## TOLEDO - LUCAS COUNTY PLAN COMMISSIONS

REF: PUD24-0001  
DATE: February 14, 2025

SUBJECT: Planned Unit Development for Multiple Commercial Buildings on a Lot at 3027 Alexis Road

SITE LANDSCAPE PLAN  
MAJOR SITE PLAN REVIEW

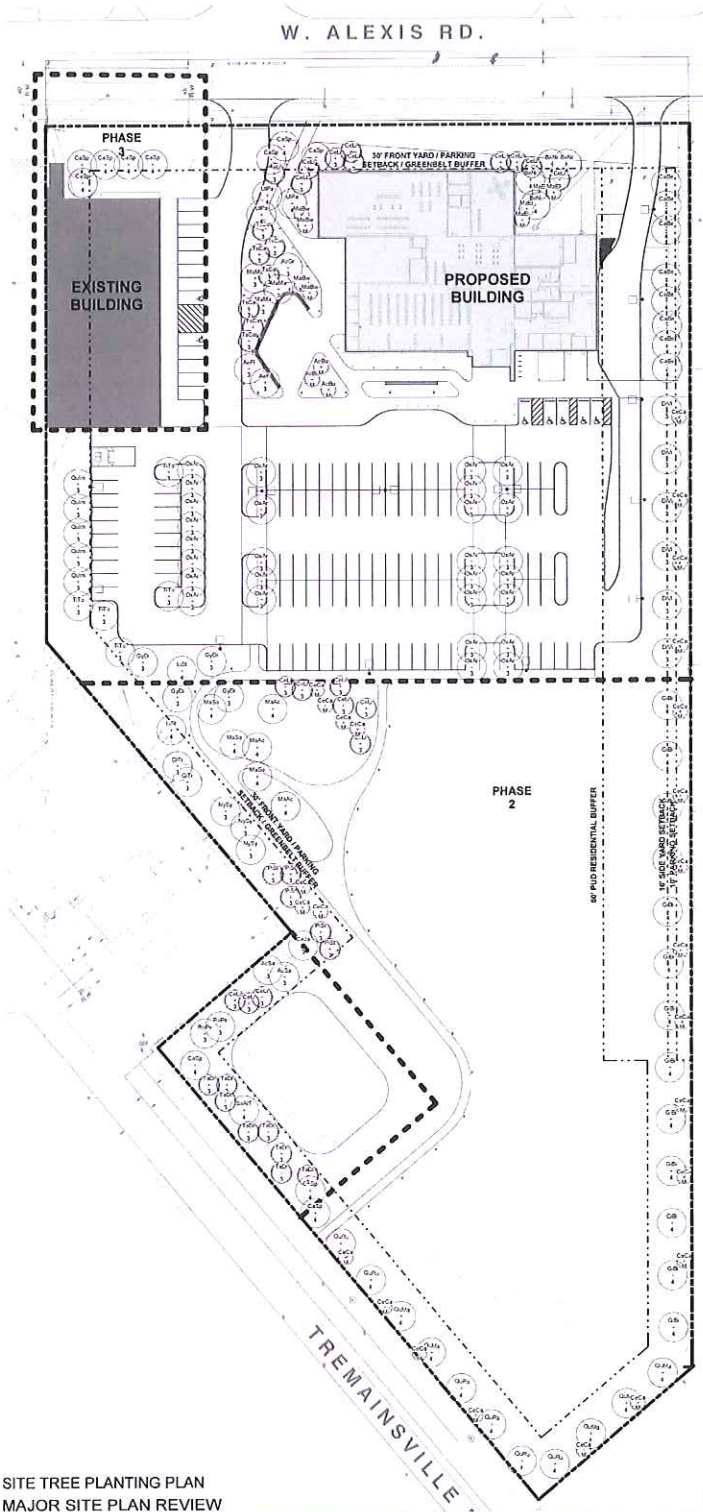
- c. Per TMC§1108.0204, two (2) canopy trees and six (6) shrubs are required to be installed in interior landscape areas in a parking lot for each ten (10) parking spaces. A total of twenty-six (26) trees and seventy-eight (78) shrubs are required in the interior of the parking lot based on the proposed 129 parking spaces. The submitted tree planting plan and shrub planting plan depict thirty (30) trees and forty-six (46) shrubs. **Not acceptable as depicted. An additional thirty two (32) shrubs are required.**

- d. Perimeter landscaping must be installed along any parking lot area adjacent to a street, place or driveway, or which is visible from an adjacent property. The tree planting plan and shrub planting plan depict trees and shrubs along the west side of the parking lot, and trees and a six-foot (6') high cedar privacy fence along the east side of the parking lot. **Not acceptable as submitted. The proposed continuous shrub hedge depicted on the shrub planting plan along the west side of the parking lot shall be extended to the south to include the drive aisle. The shrub hedge shall consist of evergreen shrubs. The privacy fence is acceptable in lieu of the required continuous shrub hedge along the east side of the parking lot per the Plan Director.**

- e. Per TMC§1108.0205(B), one 2-inch caliper tree for every 1,000 square feet of building coverage, foundation plantings along all portions of the building that are visible from the public rights-of-way, and landscaping at all major building entrances are required. **Not acceptable as depicted. A mix of trees, shrubs and groundcover shall be provided as foundation plantings along the entirety of the north, west and east sides of the building as well as at the main entrance.**

- i. Topsoil must be back filled to provide positive drainage of the landscape area.
  - j. The location, number, height, diameter, and species of any materials to be planted and maintained, as well as the location and number of any existing trees to be retained. **Not acceptable as depicted. A landscape plan shall be submitted that includes all proposed plant materials that are appropriately labeled.**
